# ARACO CONCRETE

SITE DEVELOPMENT PLAN  
EL PASO COUNTY, COLORADO

**ARACO CONCRETE**  
**SITE DEVELOPMENT PLAN**  
A PORTION OF THE SOUTHEAST QUARTER OF SECTION 24,  
TOWNSHIP 15 SOUTH, RANGE 66 WEST OF THE 6TH P.M.,  
EL PASO COUNTY, COLORADO

# SDP\_V1.pdf Markup Summary

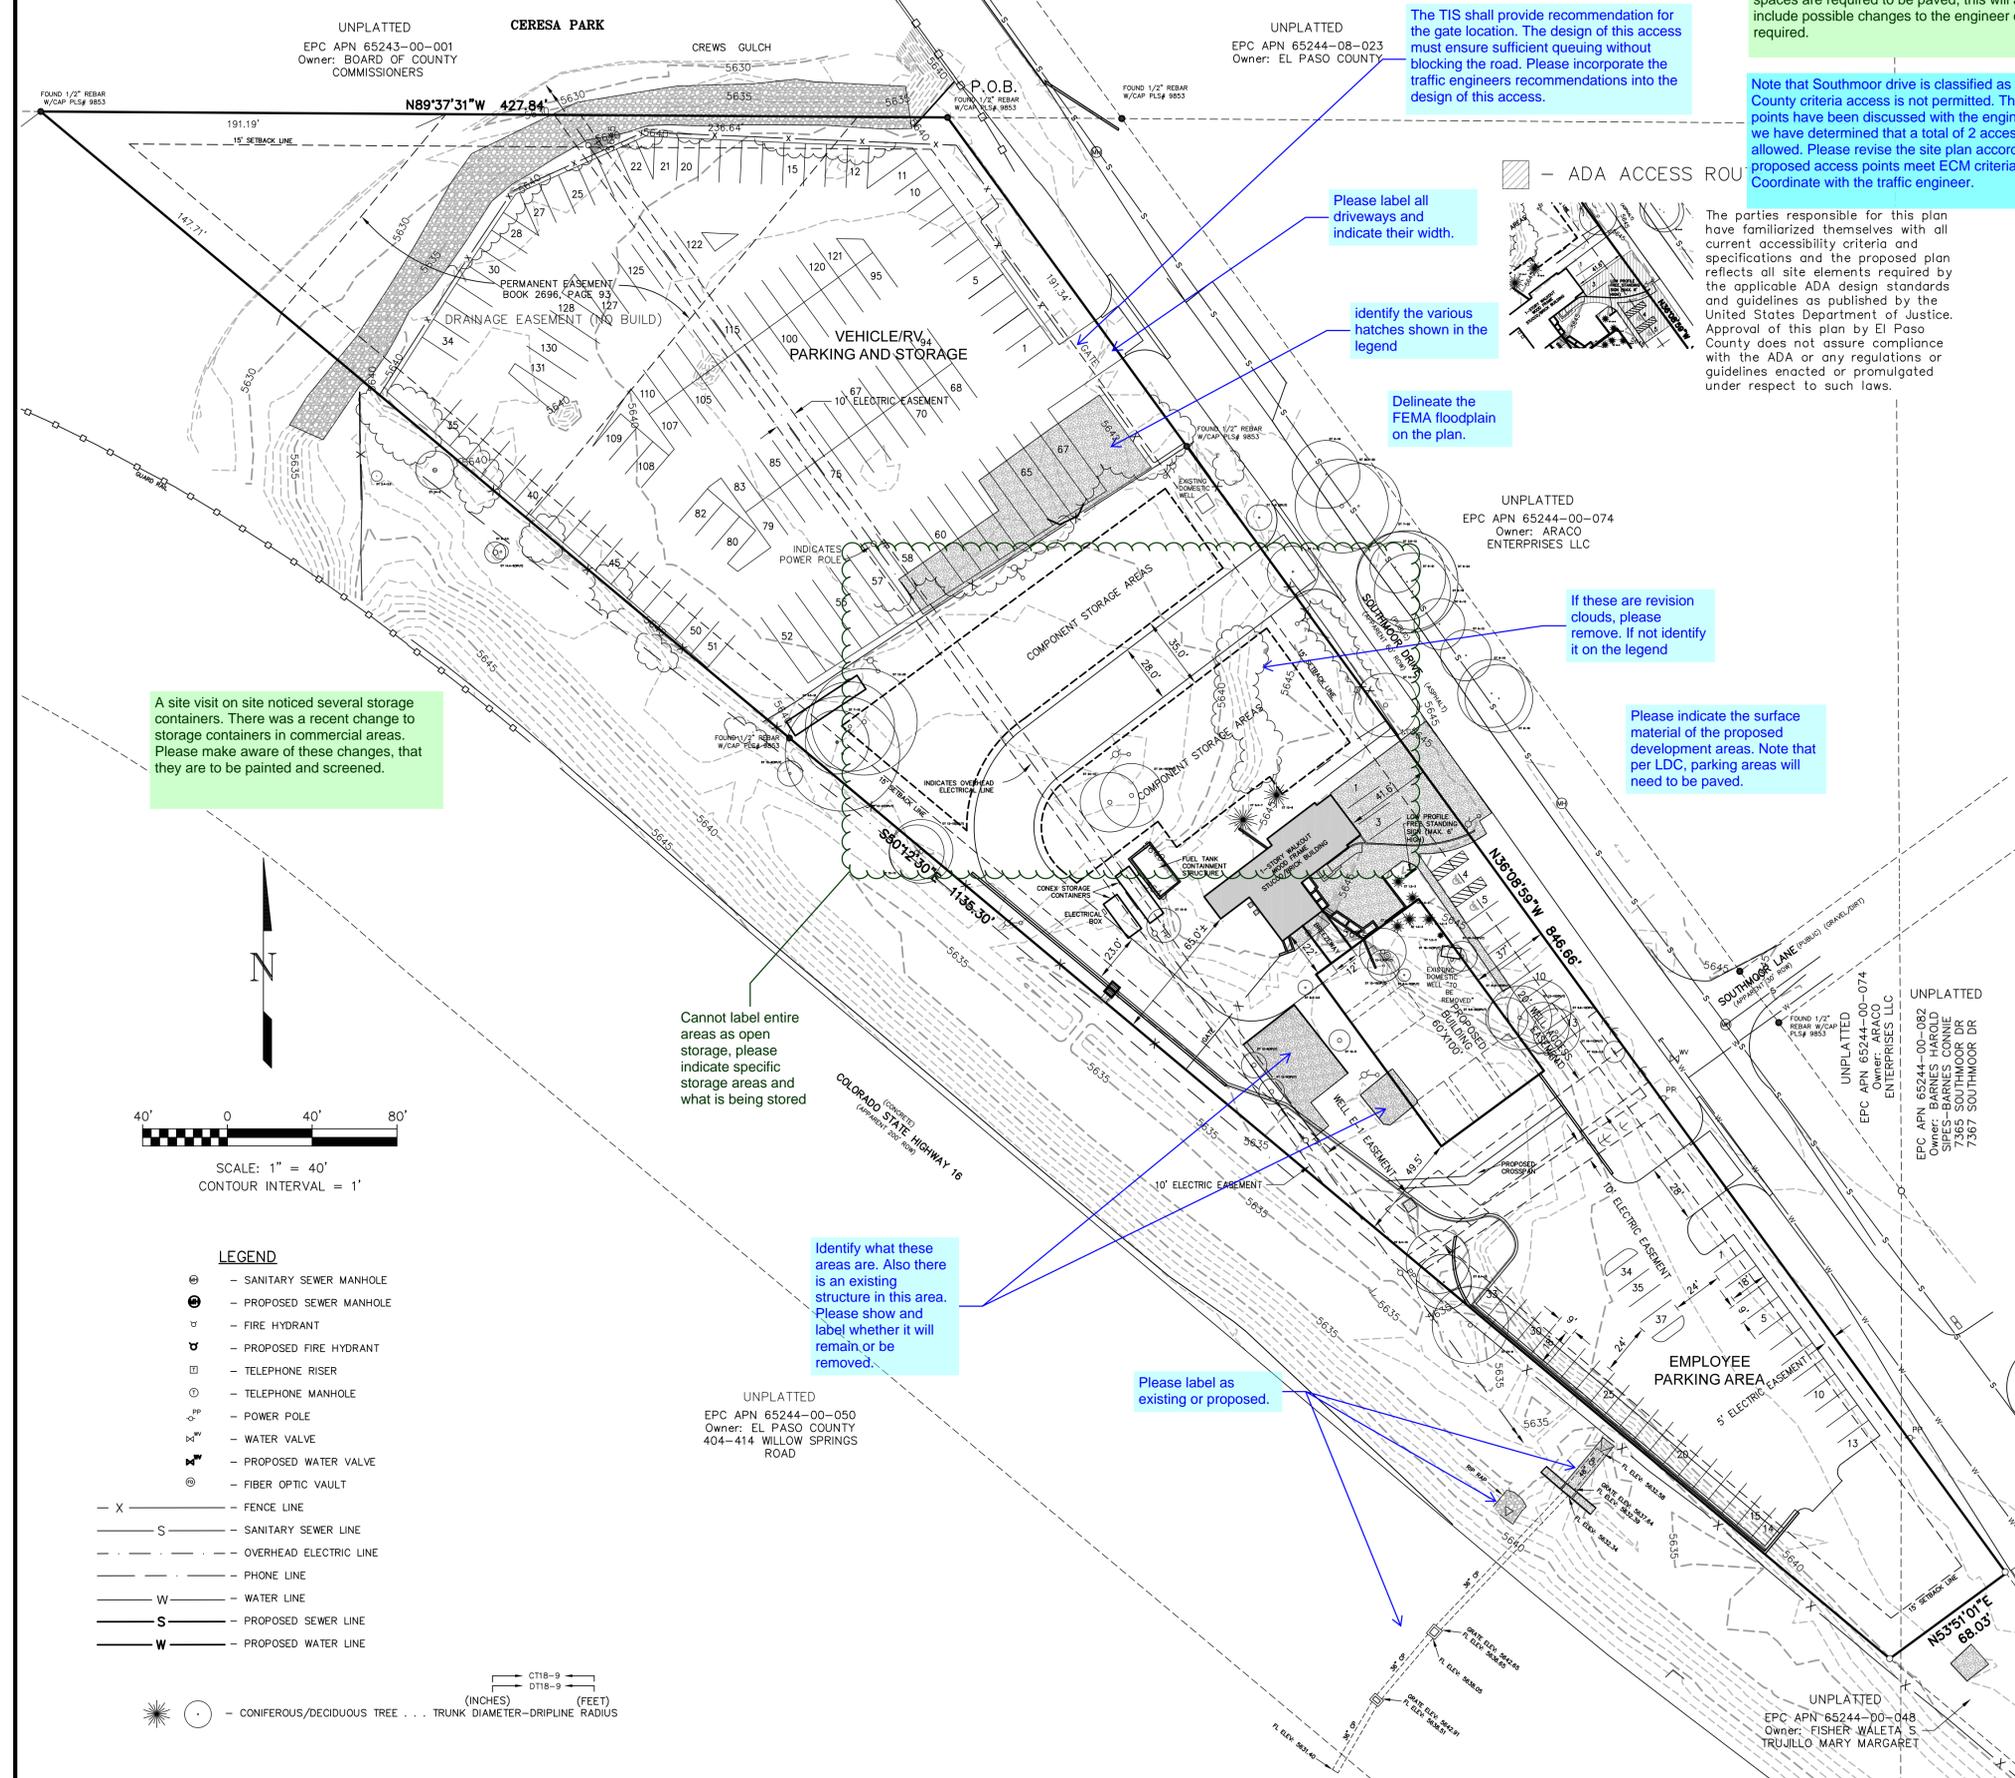
These uses were not discussed at previous EA, the only request was for the construction of the 6,000 sf building. This is considered an urban lot, and parking lot that has 5 or more spaces are required to be paved, this will alter all plans to include possible changes to the engineer documents required.

Note that Southmoor drive is classified as a Collector. Per County criteria access is not permitted. The proposed access points have been discussed with the engineering manager and we have determined that a total of 2 access points will be allowed. Please revise the site plan accordingly. Ensure that the proposed access points meet ECM criteria (see ECM 2.4.1). Coordinate with the traffic engineer.

The TIS shall provide recommendation for the gate location. The design of this access must ensure sufficient queuing without blocking the road. Please incorporate the traffic engineers recommendations into the design of this access.

Please label all driveways and indicate their width.

Identify the various hatches shown in the legend

Delineate the FEMA floodplain on the plan.

If these are revision clouds, please remove. If not identify it on the legend

Please indicate the surface material of the proposed development areas. Note that per LDC, parking areas will need to be paved.

A site visit on site noticed several storage containers. There was a recent change to storage containers in commercial areas. Please make aware of these changes, that they are to be painted and screened.

Cannot label entire areas as open storage, please indicate specific storage areas and what is being stored

Identify what these areas are. Also there is an existing structure in this area. Please show and label whether it will remain or be removed.

Please label as existing or proposed.

Please update the FEMA FIRM # and date.
